PCN# : P645AAB
Issue Date : Apr. 12, 2016

Information Only Notification

Figure 1. On-Region Characteristics

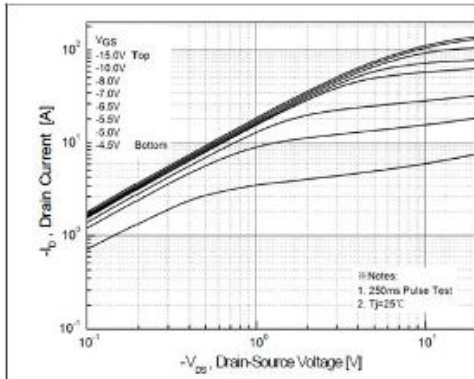
1. Existing Figure 1, On-Region Characteristics (page 3)
2. Existing Figure 3, On-Resistance Variation vs. Drain Current and Gate Voltage (page 3)

Figures 1 and 3 were updated and corrected based on correct test data.

1. Updated Figure 1, On-Region Characteristics (page 3)
2. Updated Figure 3, On-Resistance Variation vs. Drain Current and Gate Voltage (page 3)
